Topic: ENERGY STAR® Version 5.0 Commercial Refrigerators and Freezers Discussion Guide

This letter comprises the comments of the Pacific Gas and Electric Company (PG&E), San Diego Gas and Electric (SDG&E), and Southern California Edison (SCE) in response to the United States (U.S.) Environmental Protection Agency (EPA) ENERGY STAR® Version 5.0 Commercial Refrigerators and Freezers Discussion Guide.

Figure 1: DEC and refrigerated volume of chef base and work-top refrigerator data sources.

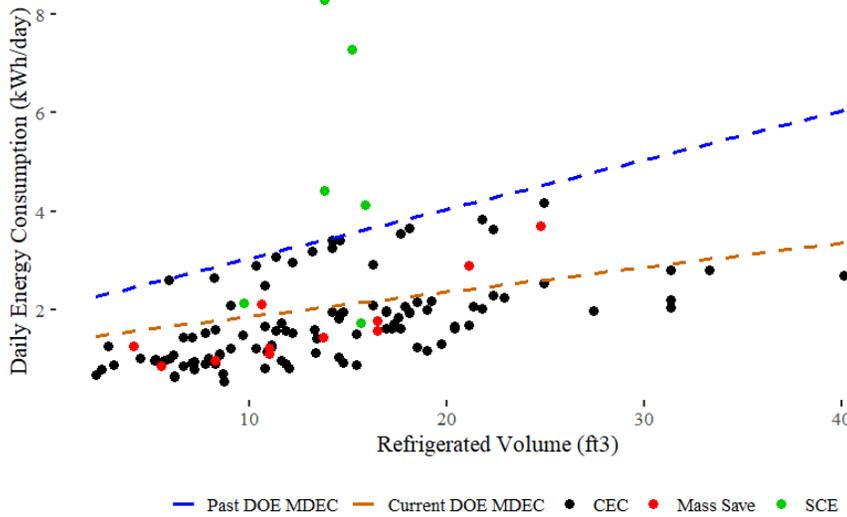
Product design specifics aside, we note strong similarities in the DEC of chef bases and worktop refrigerators which form a useful baseline understanding of the market, see Figure 1. Based on the combined data set shown in the preliminary analysis below, we believe that currently-certified commercial refrigeration equipment with similar form factors to chef bases¹⁴ may be an appropriate starting point for developing a proposed Draft 1 DEC requirement for chef bases.

We anticipate that ENERGY STAR MDEC requirements for chef bases would be a function of refrigerated volume similar to past DOE requirements¹⁶ for solid door refrigerators and existing DOE MDEC requirements for Vertical Closed Solid, Self-Contained, Medium Temperature Refrigerators (VCS.SC.M).¹⁷ We note that the data set of known chef bases (i.e., SCE [green points], Mass Save [red points]) in Figure 1 have units from the full refrigerated volume range (i.e., <5 ft³ to 25 ft³) meeting the 2010 DOE standards, and units below 20 ft³ meeting the 2017 current DOE MDEC requirement. We encourage EPA to request additional DEC and refrigerated volume data from manufacturers of chef bases to further refine the DEC distribution across this product type, confirming whether the DOE MDEC for VCS.SC.M is an appropriate energy performance requirement for efficient chef bases.
